SOLICITATION ADDENDUM NO. 2

Project Title	Date Prepared	Project No.
SJCCD Maritime Expansion Fire Training Center	December 4, 2019	CSP 20-12

ADDENDUM NO. 02

Project: **Maritime Expansion Fire Training Center**
 San Jacinto Community College District

C1.04
 SITE DETAILS

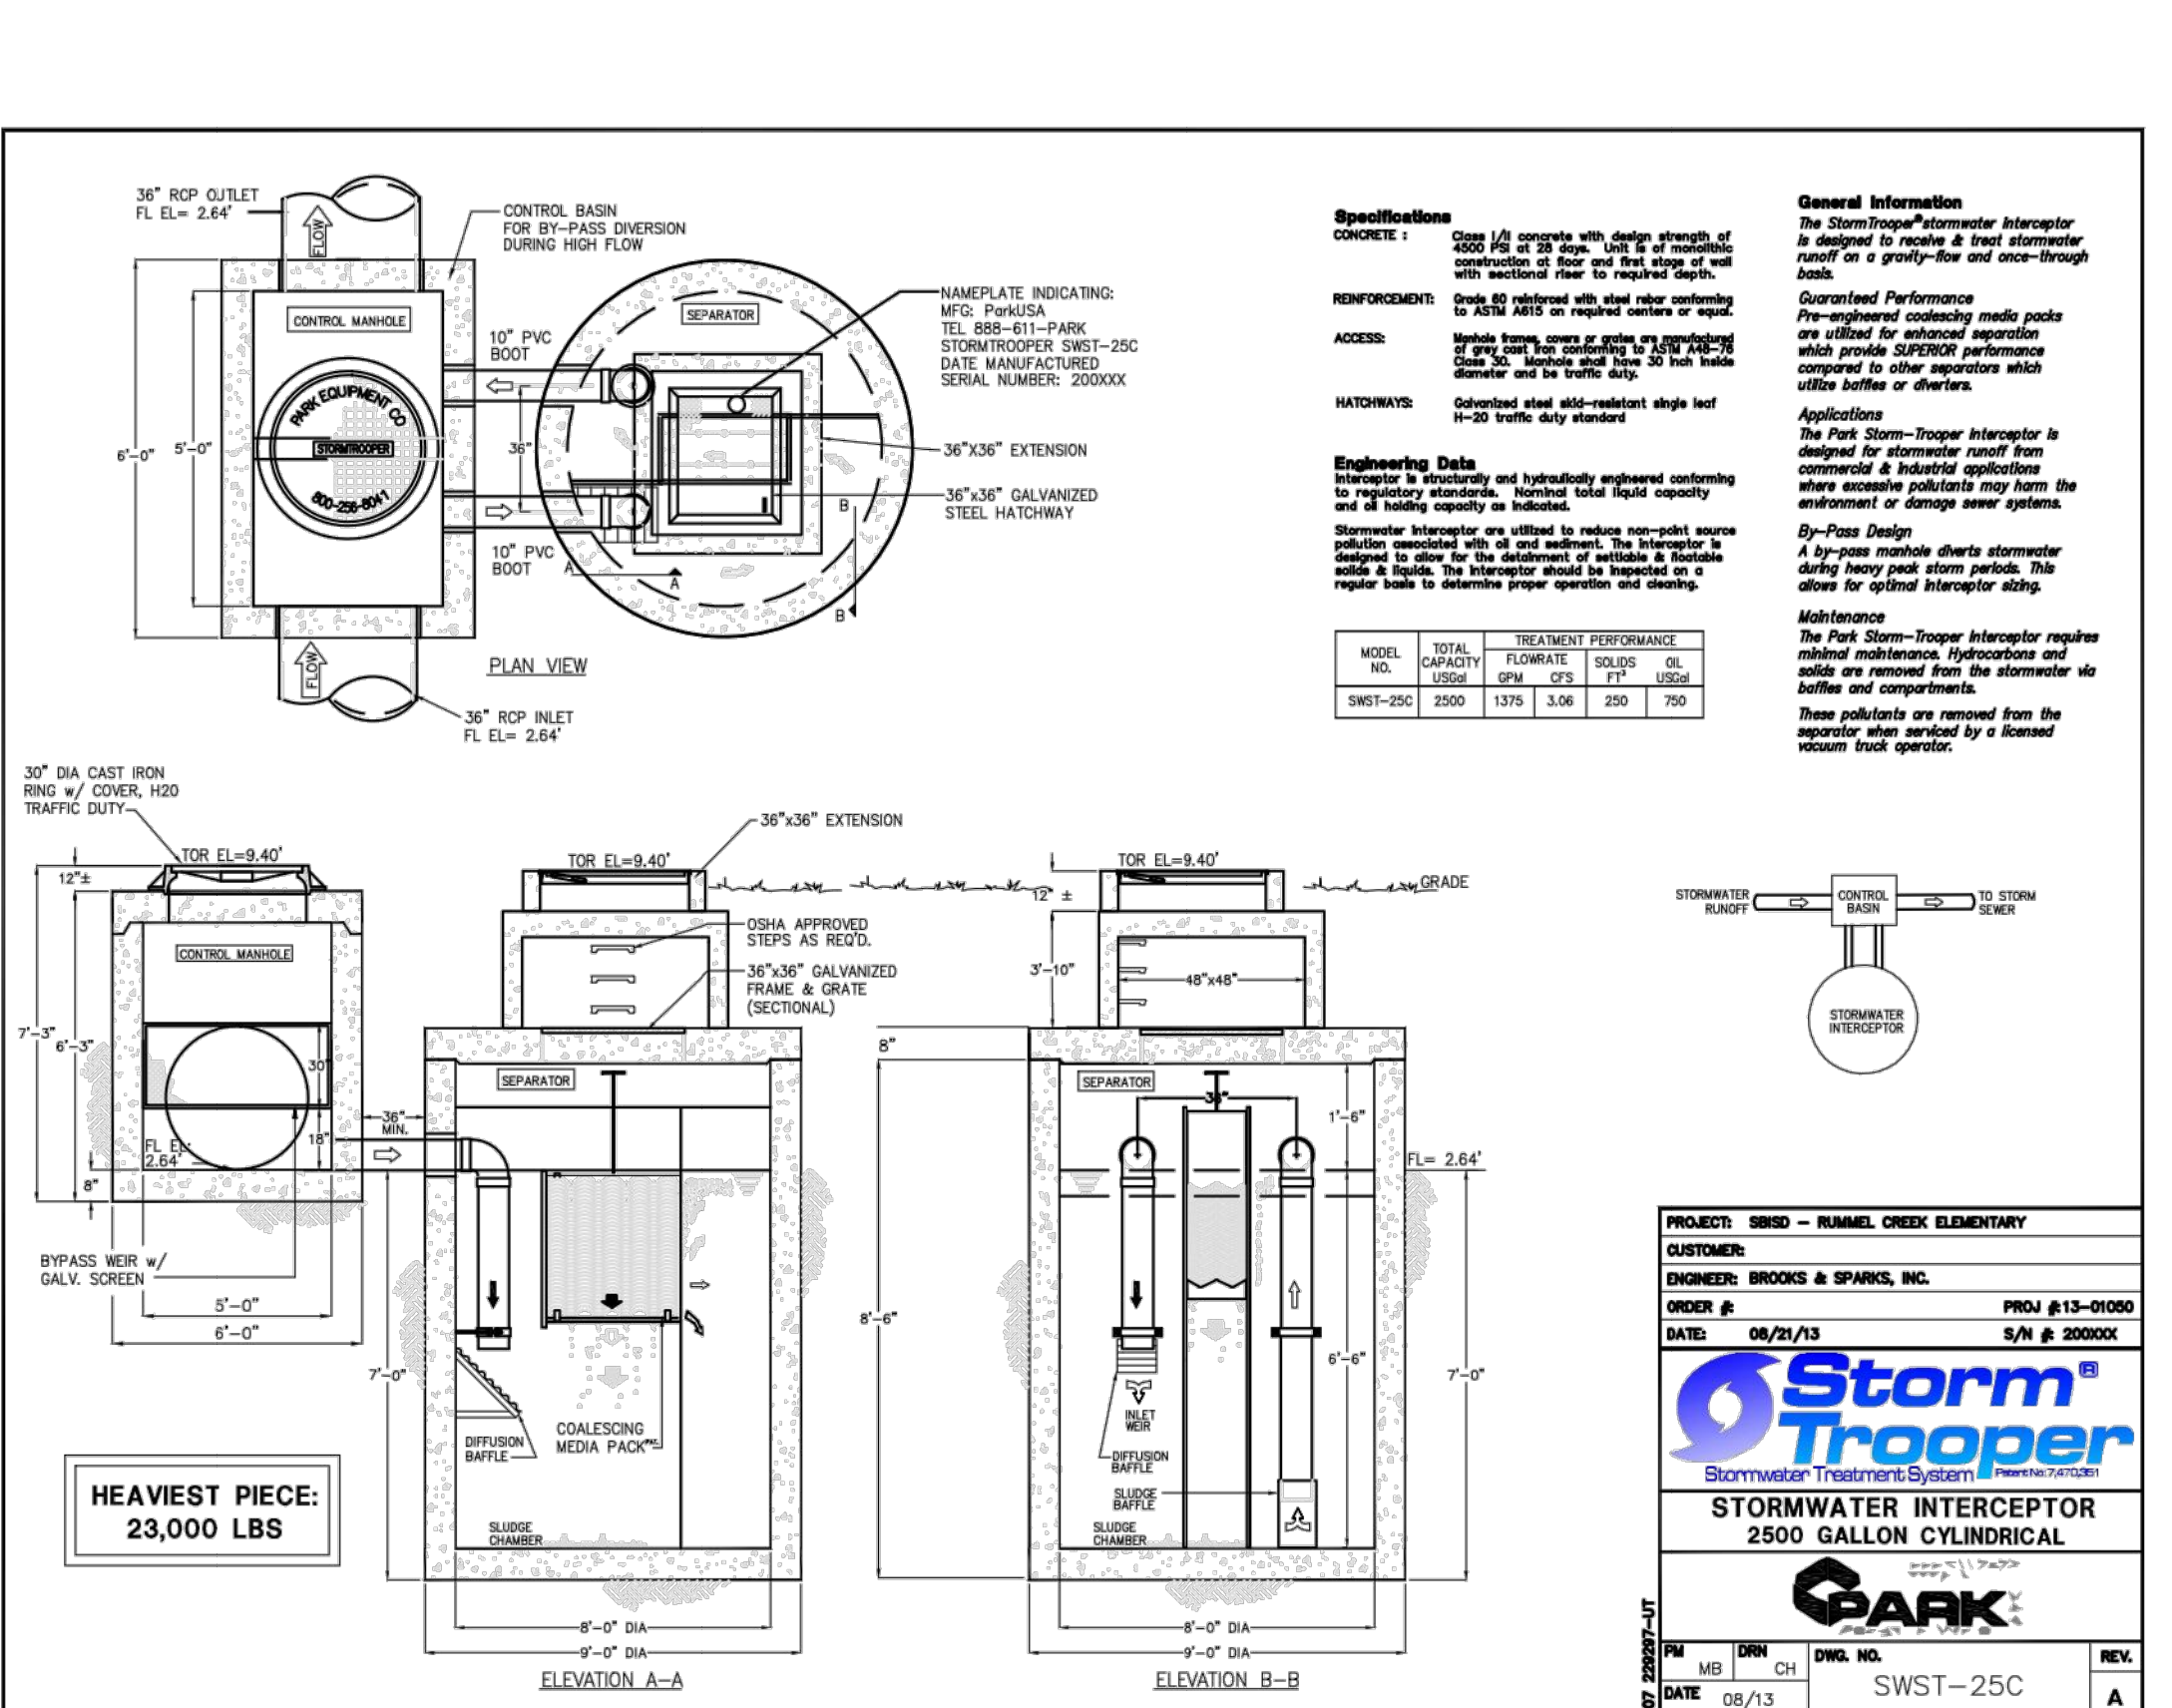
15. Sheet C1.04 – Site Details
 - a. Detail 4 has been revised
 - b. Detail 12 has been revised to show the canopy over the bleachers.
16. Sheet C2.04 – Existing Storm Sewer and SWQ Plan

GRADING & PAVING PLAN

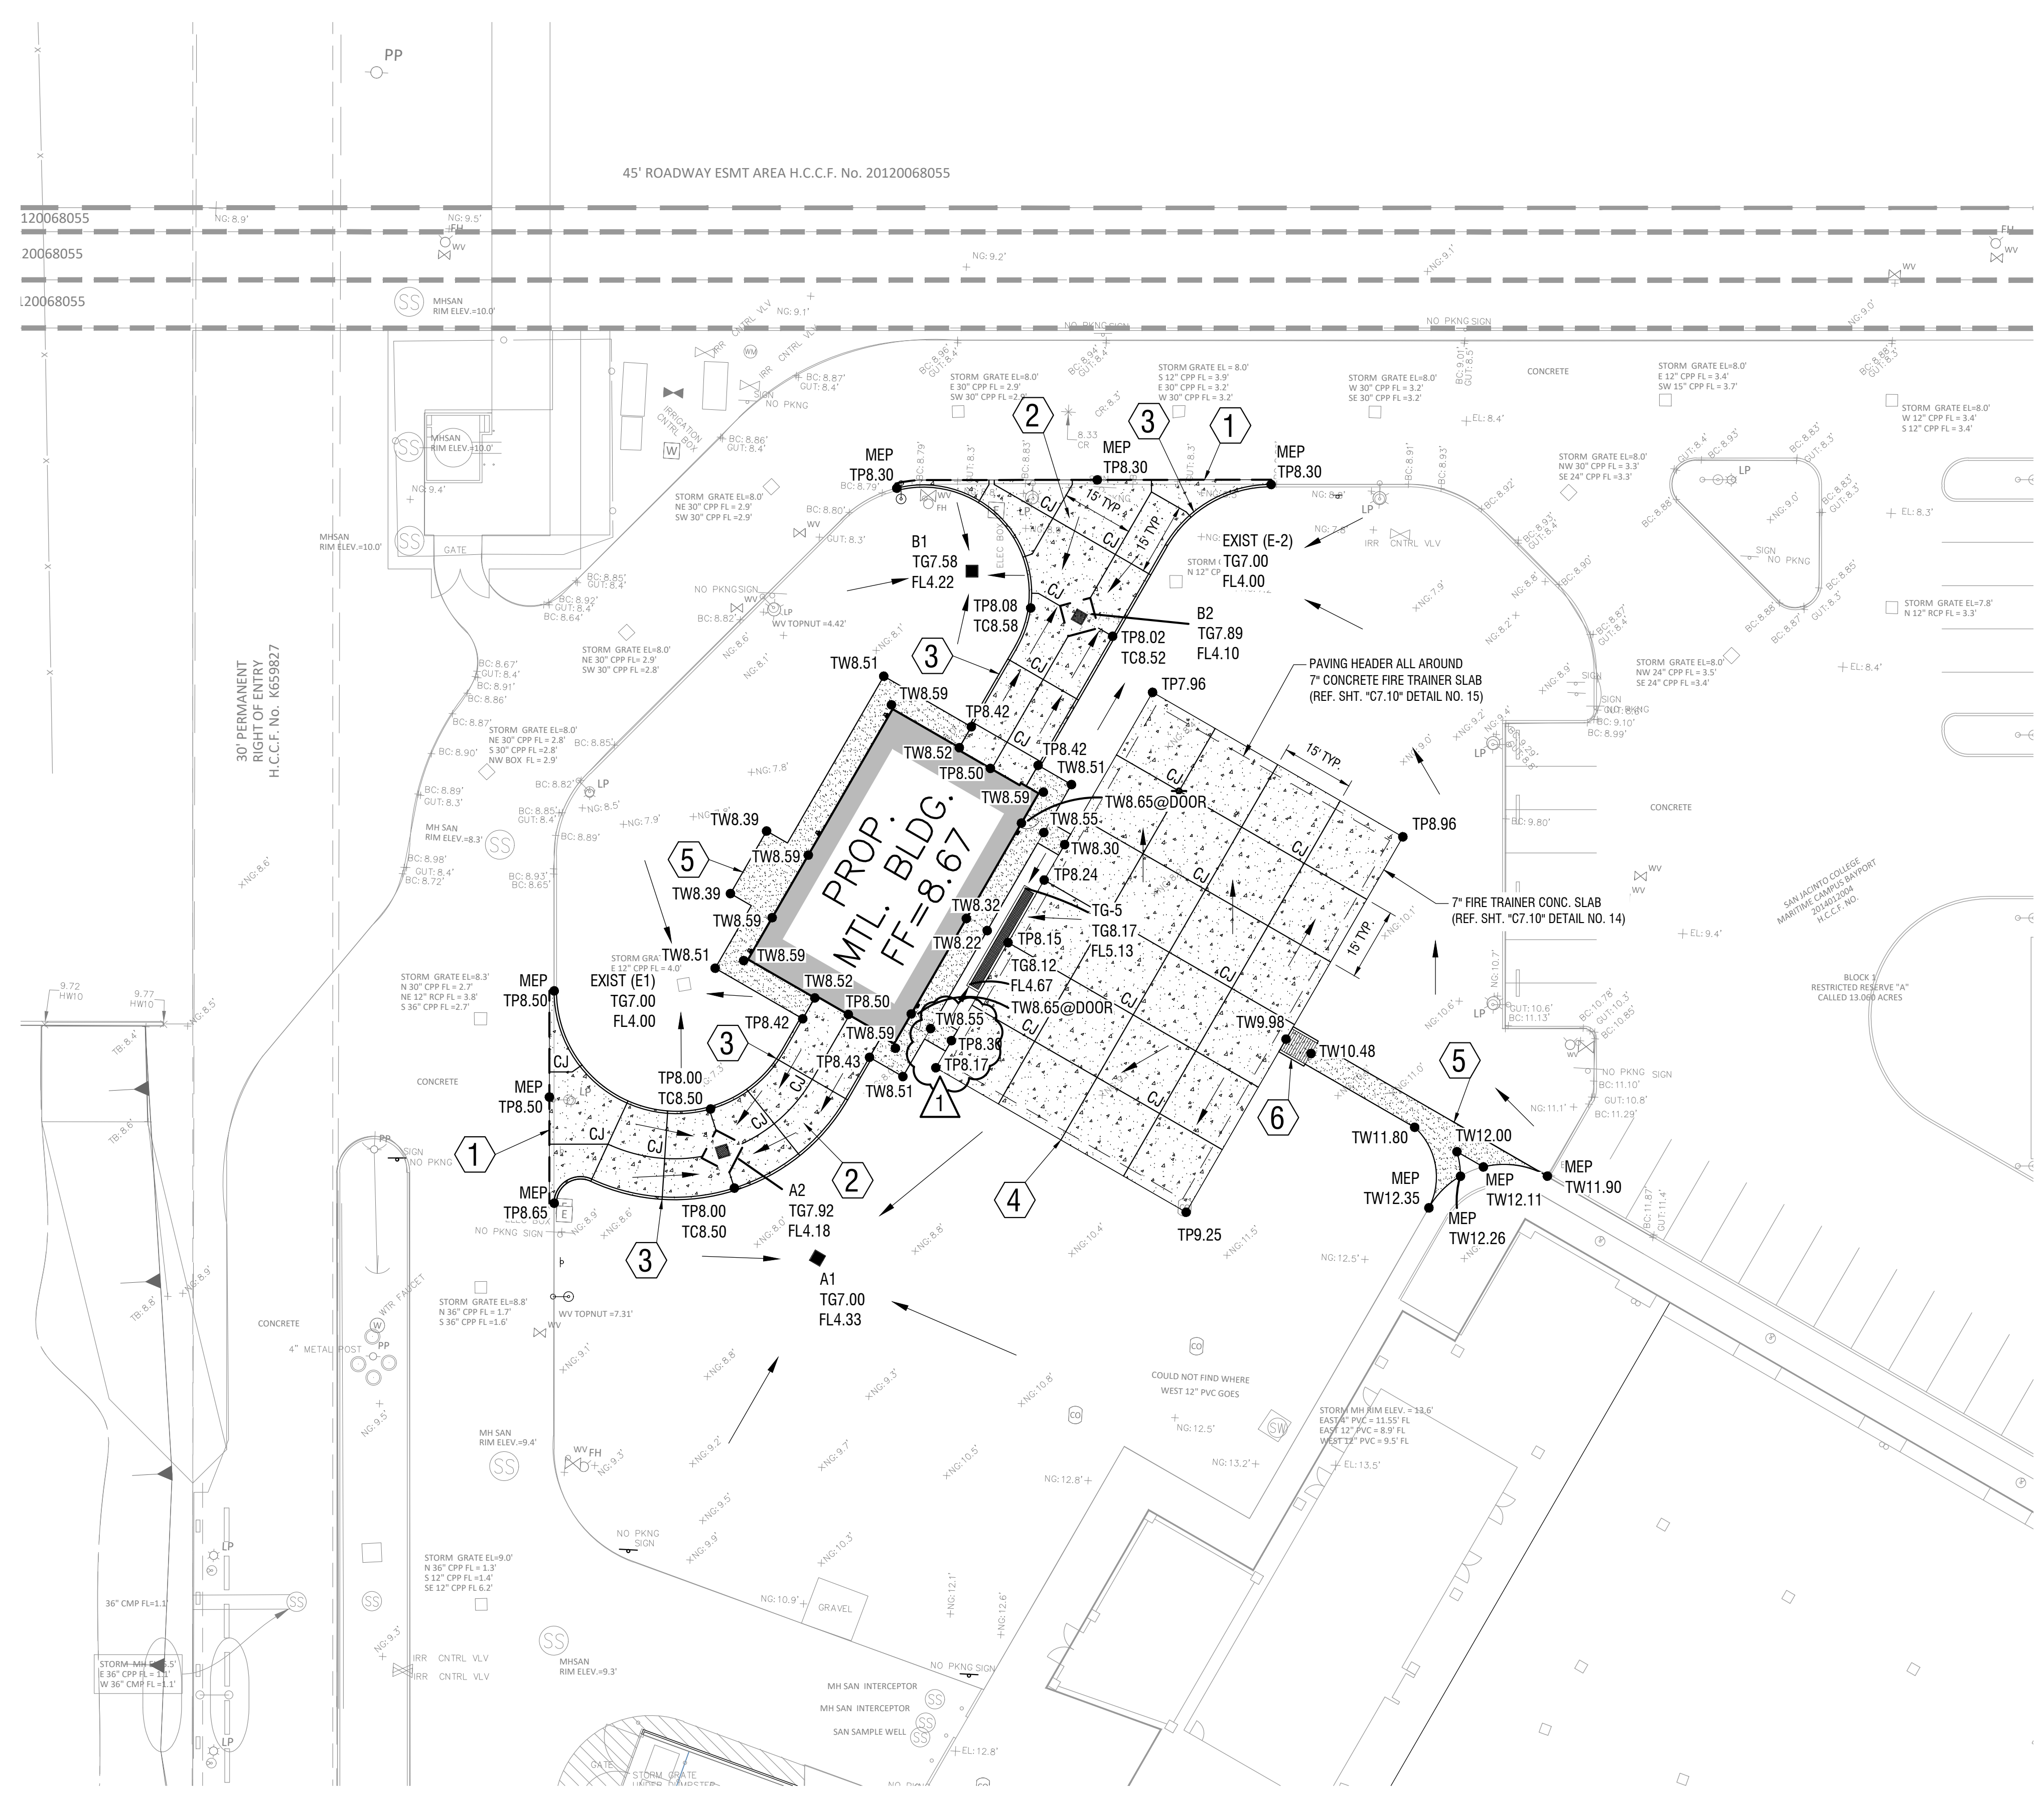
17. Sheet C6.00 - Grading & Paving Plan
 - a. Removed old Keynote 6 callout between the proposed metal building and the concrete pad as that ramp was removed in this area.
